METROPOLITAN GOVERNMENT OF NASHVILLE AND DAVIDSON COUNTY

STAFF RECOMMENDATION 3618 Richland Avenue February 18, 2015

Application: Partial demolition; New construction—addition
District: Richland-West End Neighborhood Conservation Zoning Overlay
Council District: 24
Map and Parcel Number: 10409008700
Applicant: J. B. Haile, Haile Construction
Project Lead: Melissa Baldock, melissa.baldock@nashville.gov

Description of Project: Application is to demolish an existing addition and construct a new addition.

Figure 5 (left) shows the current conditions of the two-story rear addition, and Figure 6 (right) is the 1932 Sanborn map showing that a two-story addition of the approximate same dimensions existed then.

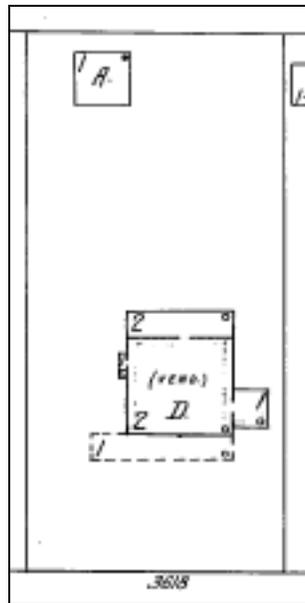
Partial Demolition: The applicant is proposing to demolish a two-story, partially enclosed rear porch (Figure 5). Although this section of the house appears on the 1932 and 1957 Sanborn maps (Figure 6), its current configuration and appearance dates to 2002 when MHZC issued a preservation permit for re-opening the ground floor porch and enclosing the second story portion of the porch. No historic fabric exists on the rear façade the house. Staff therefore finds that the demolition of the existing rear addition meets Section III.B.2 for appropriate demolition and does not meet section III.B.1 for inappropriate demolition.

1 EAST/SIDE ELEVATION
SCALE 1/4"=1'-0"

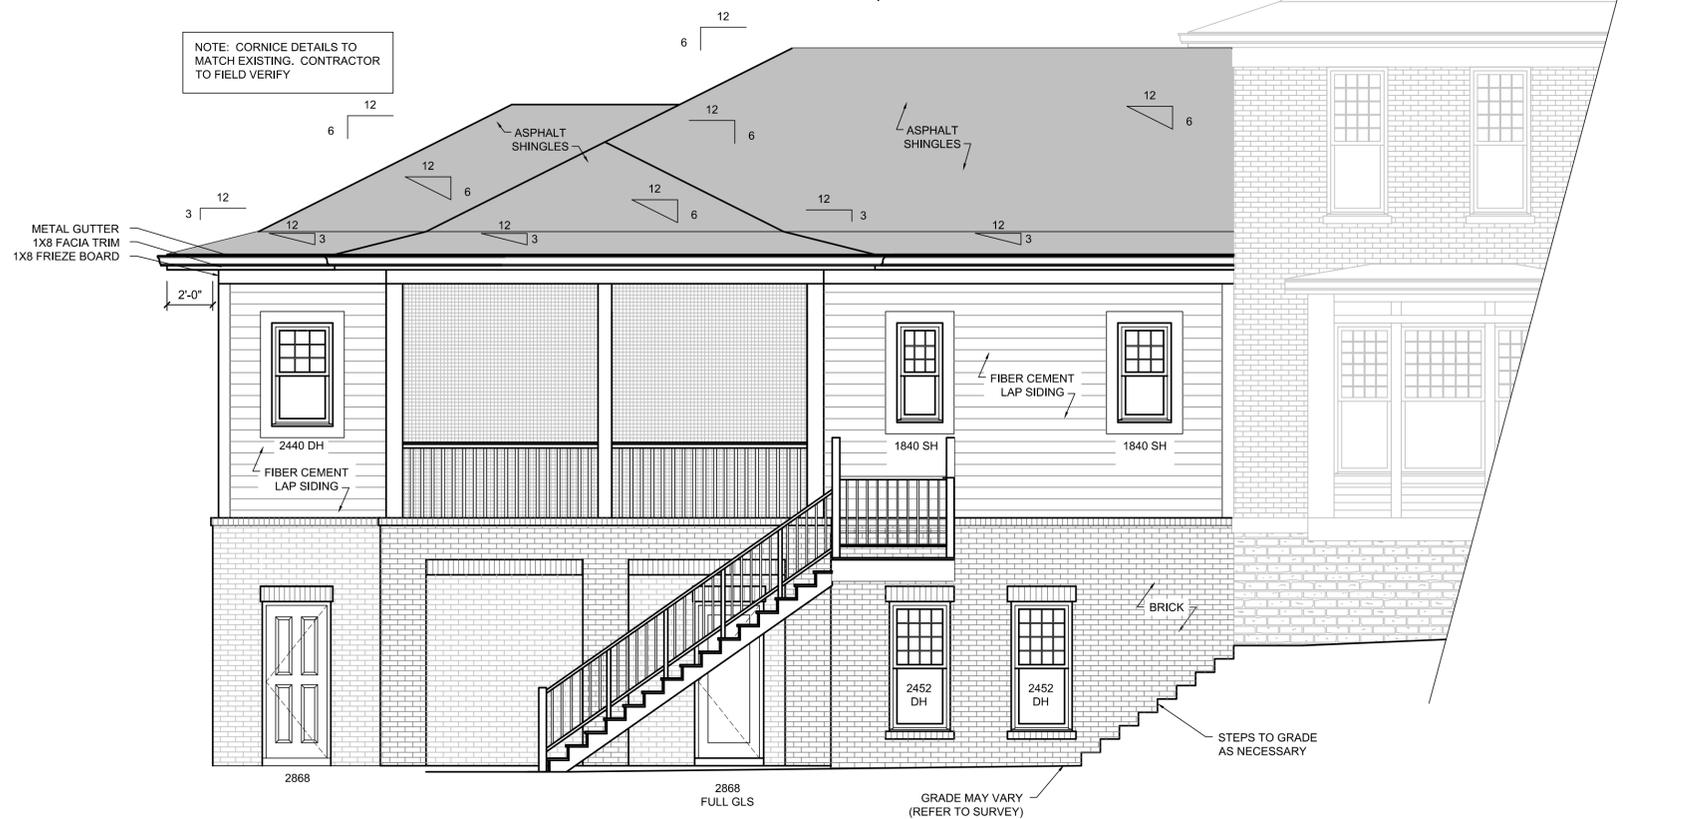
On the right side, the addition extends approximately thirty feet (30') behind the house before a two foot (2') deep by twelve feet, six inch (12'6") long bay. Staff recommends that an inset of at least two feet by four feet (2' X 4') occur along the thirty foot (30') expanse to help break up the length of the wall. Staff also asks that the applicant resubmit the side elevation drawings in 11 X 17 format (and also to scale).

MHJC Note: This drawing is not to scale

With the condition that the applicant create 2' X 4' inset along the right elevation, staff finds that the addition's height and scale meet Sections II.B.1.a.and b. and II.B.2. of the design guidelines.
